**DATE:** 02.21.2018  
**TO:** ProTrak  
**FROM:** Mitesh Baxi  
Traffic Engineering

■ **ROLAND GRISE MIDDLE RENOVATIONS [TRC Plan Review]**

☞ Initial Review Note ☞

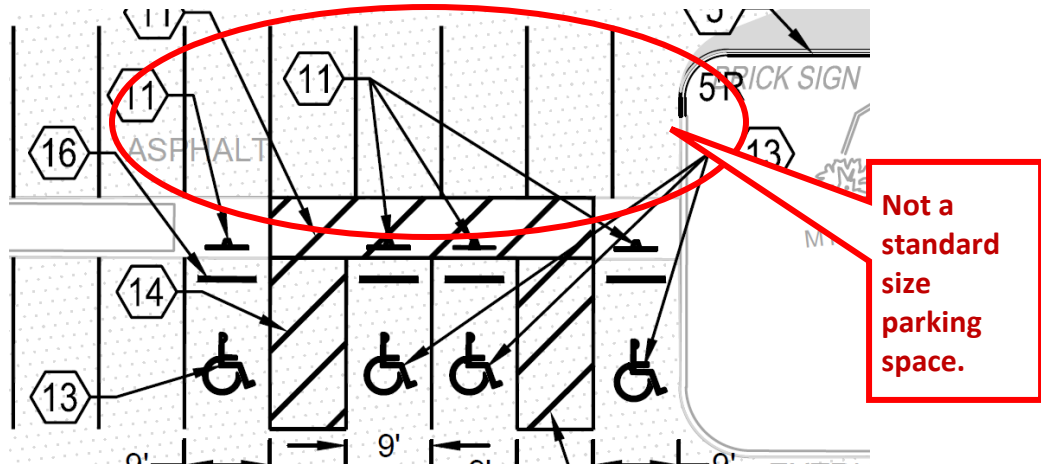
16. Show the typical handicap sign detail on the plan as per ADA and City standards. [Sheets A1 of 5 and A2 of 5, CofW Sign Specification]
17. Please provide wheel stops for the parking spaces located to the north of the handicap spaces (See below image for the reference).

18. The parking space to the far right of the above image is not as per standard size. Please provide the dimension.
19. The handicap parking spaces for this site does not have an accessible route. An accessible route must be provided to connect an accessible aisle to the accessible ramp at the nearest entrance of the building. [\[ADA Regulations\]](#)
20. Bicycle parking is noted in the site data. Please show the location of the bicycle rack on the site plan. Bicycle parking facilities shall be provided within two hundred (200) feet of the primary entrance to the facility. In the event of multiple entrances, bicycle-parking facilities shall be dispersed for easy access to the multiple entrances. [\[Sec.18-528\(f\) CofW LDC\]](#)
